SUNSET VILLAGE FILING NO. 4

CONSTRUCTION PLANS

**CONSTRUCTION DRAWINGS AMENDMENT,
DATED APRIL 4, 2026 BY ENGINEERING LOCAL
XPRTS, LLC.**

REVISION 1: 01/07/2022
COR218 REVISION 2 (ELX
JULY 2026)

PHASE 2 (BLACK ELK DRIVE AND PIPESTEM DRIVE)

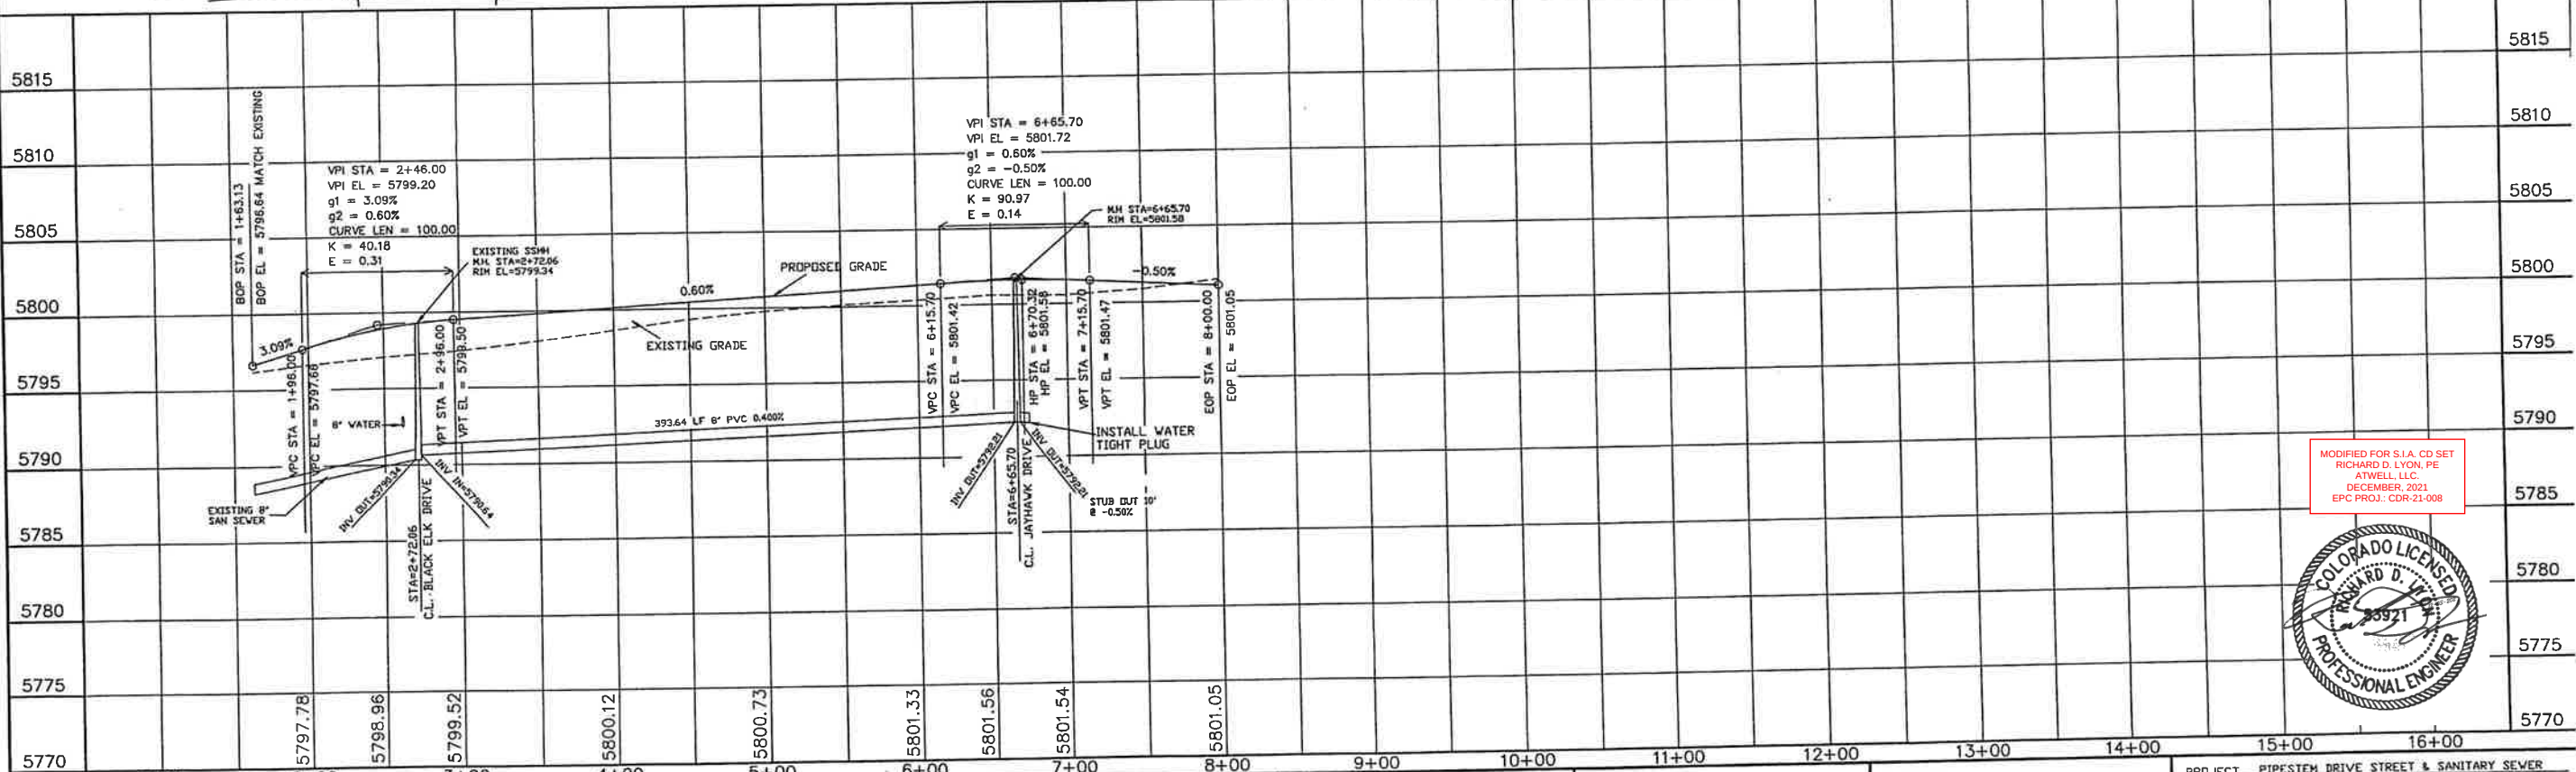
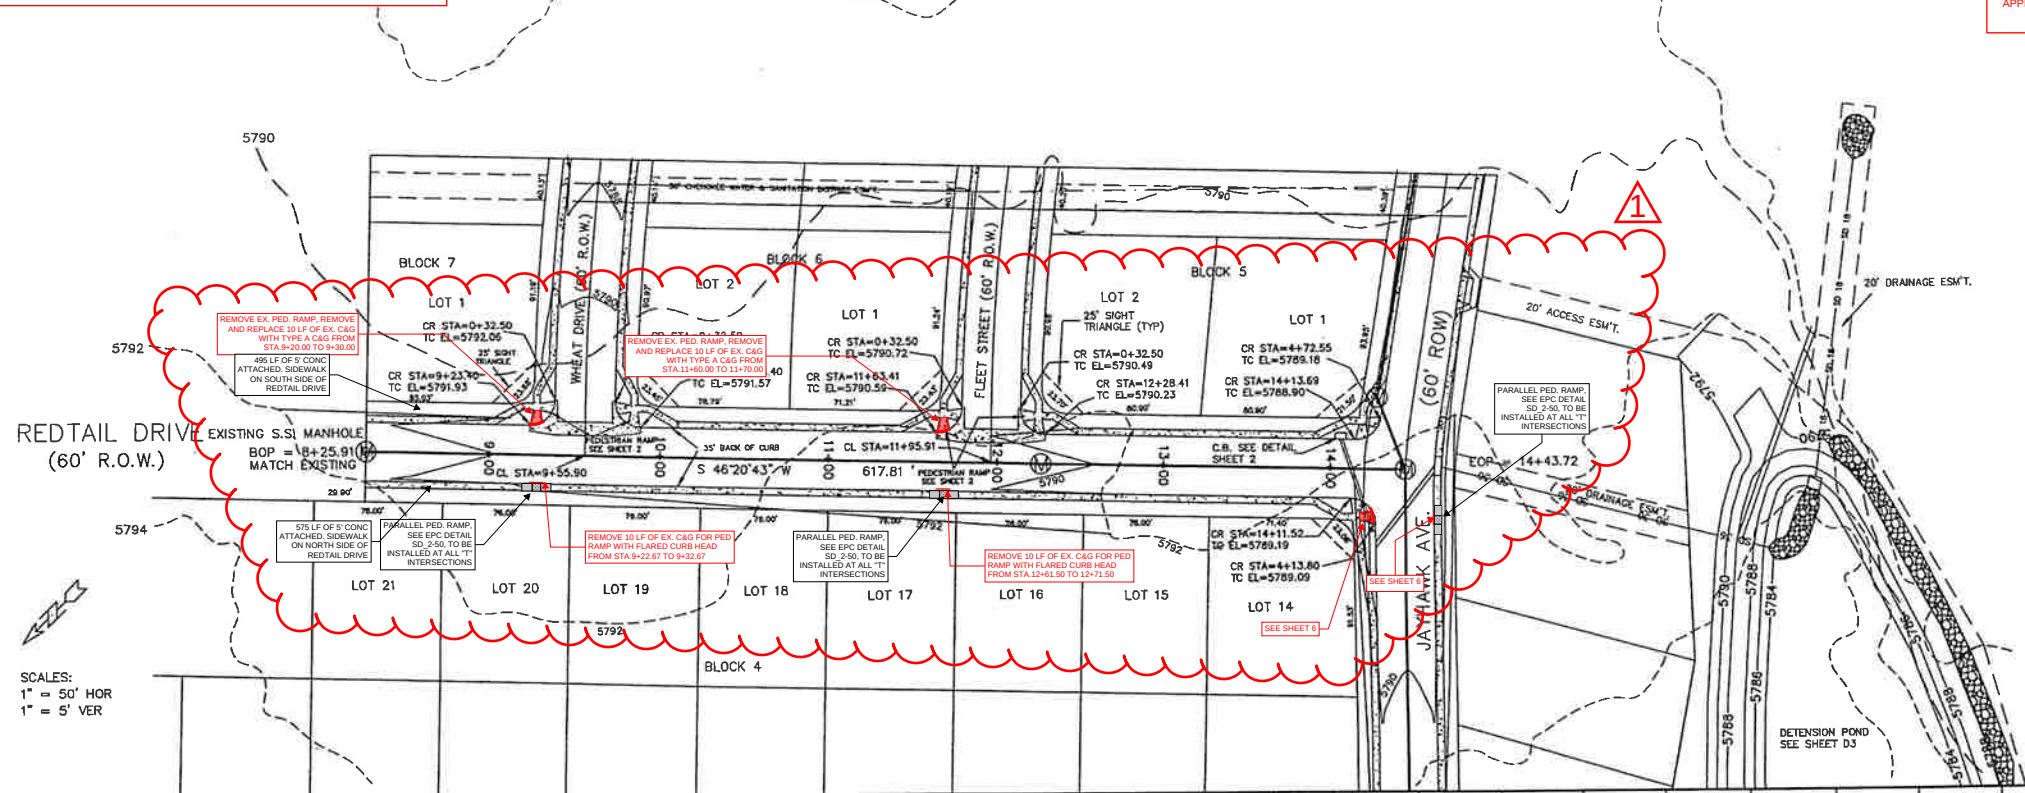
* CURB AND GUTTER MARKED IN THE FIELD TO BE REPLACED IN-KIND. ESTIMATED TO BE APPROXIMATELY 900 LF IN TOTAL.

PHASE 1 (REDTAIL DRIVE, WHEAT DRIVE, FLEET STREET, JAYHAWK AVENUE)

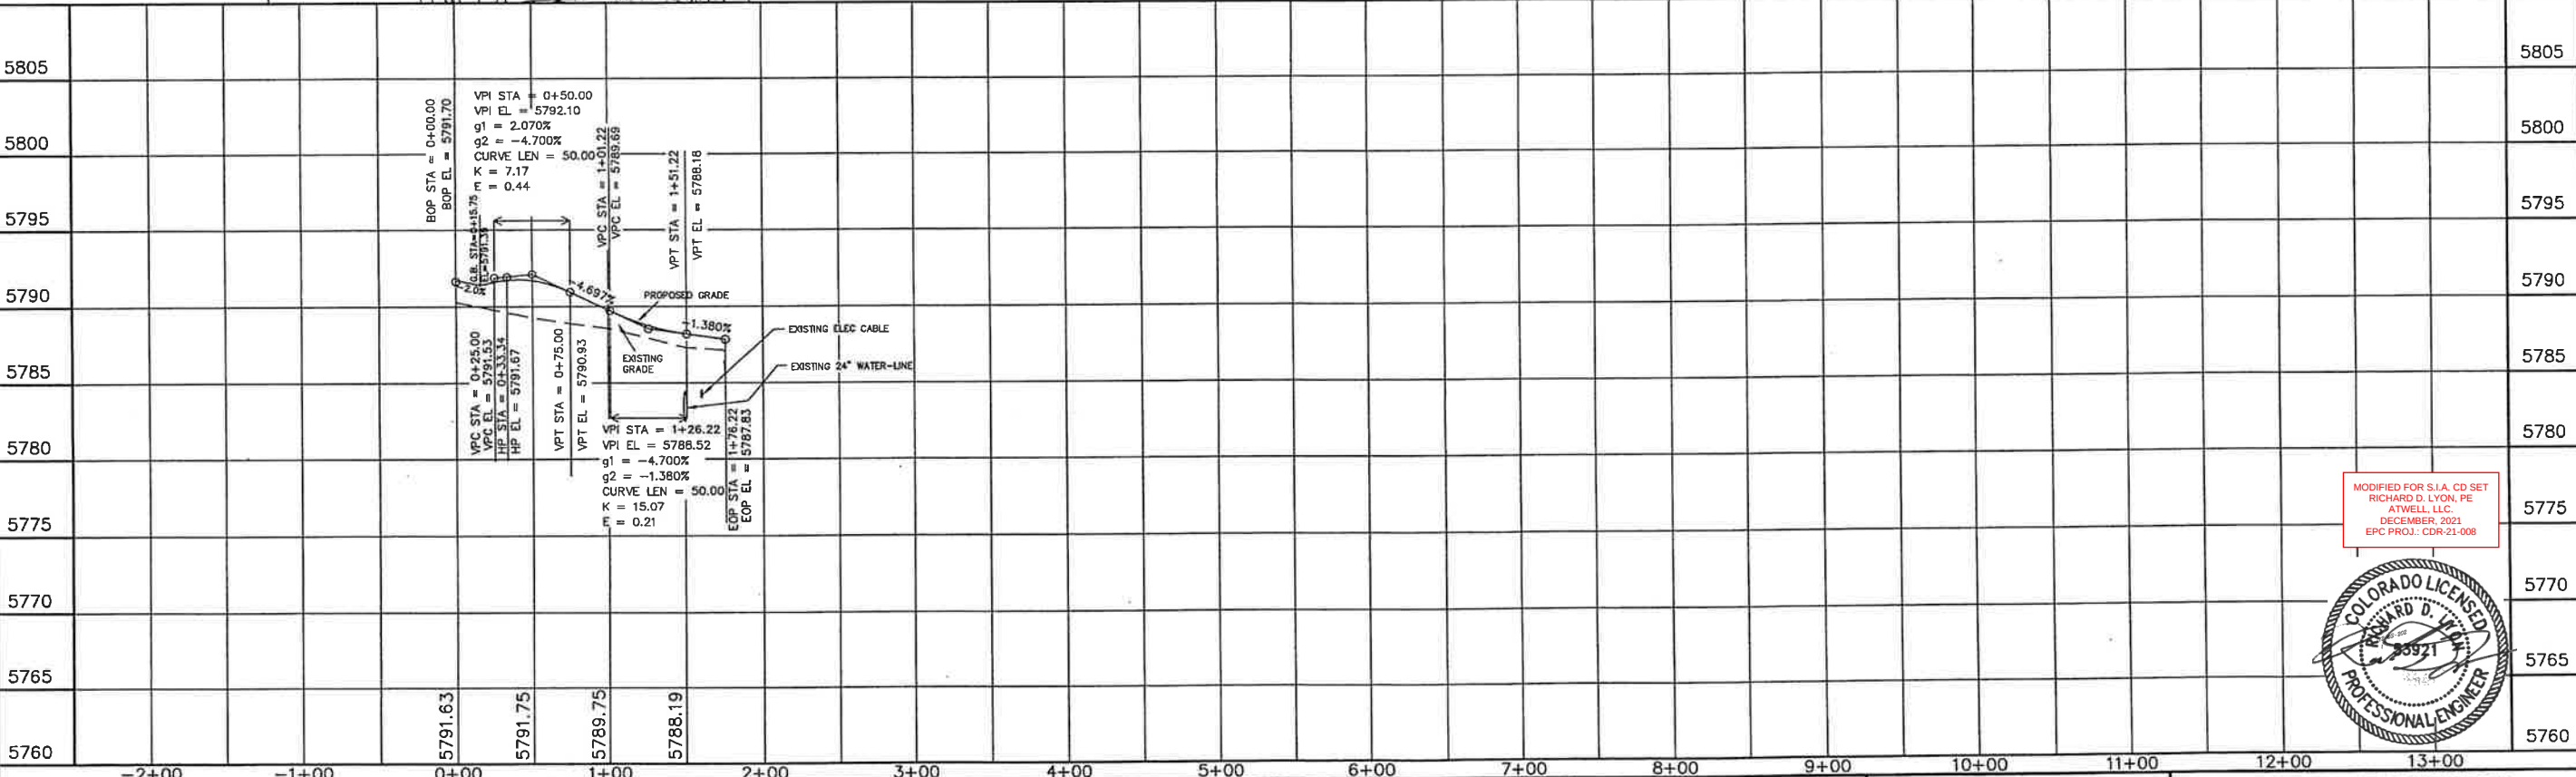
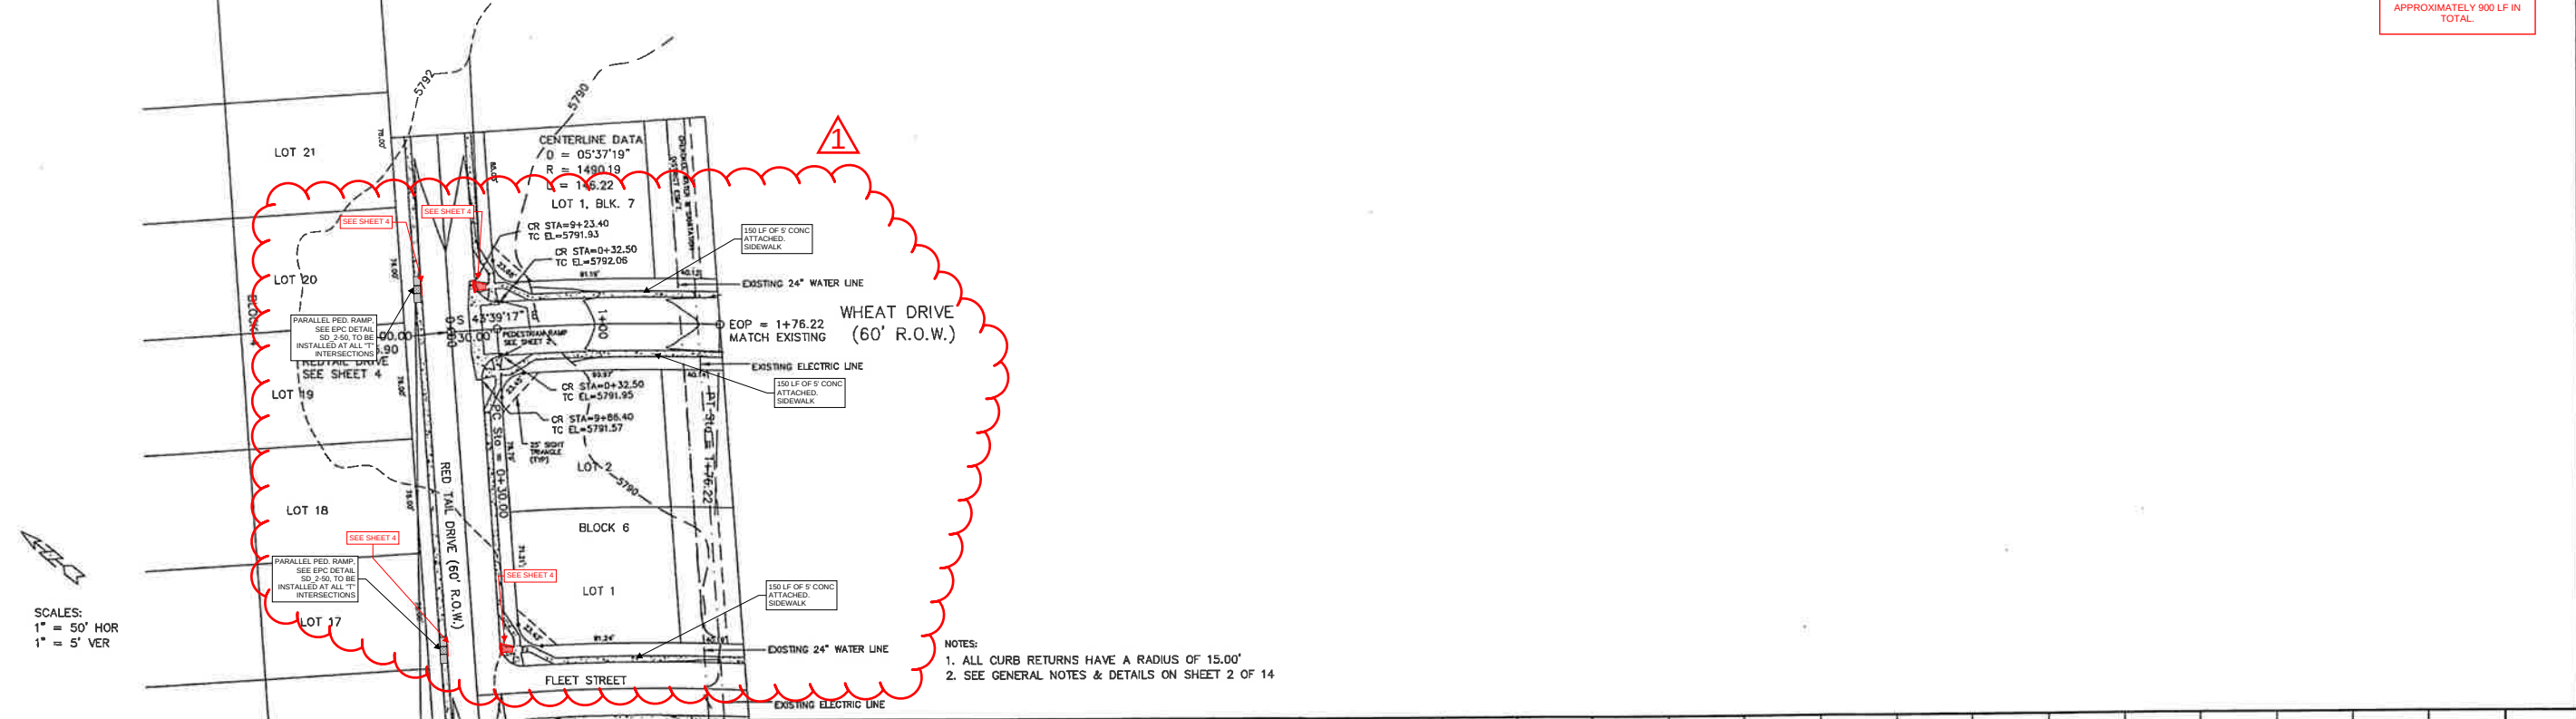
* CURB AND GUTTER MARKED IN THE FIELD TO BE REPLACED IN-KIND. ESTIMATED TO BE APPROXIMATELY 900 LF IN TOTAL.

PHASE 1 (REDTAIL DRIVE, FLEET STREET)

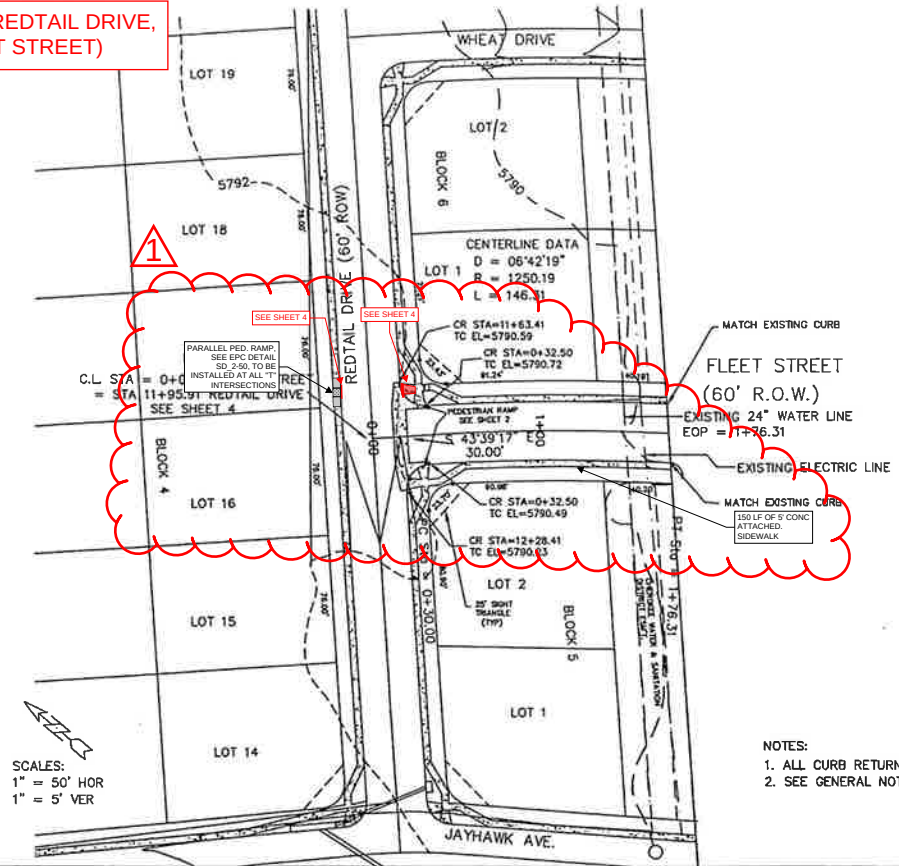
* CURB AND GUTTER MARKED IN THE FIELD TO BE REPLACED IN-KIND. ESTIMATED TO BE APPROXIMATELY 900 LF IN TOTAL.
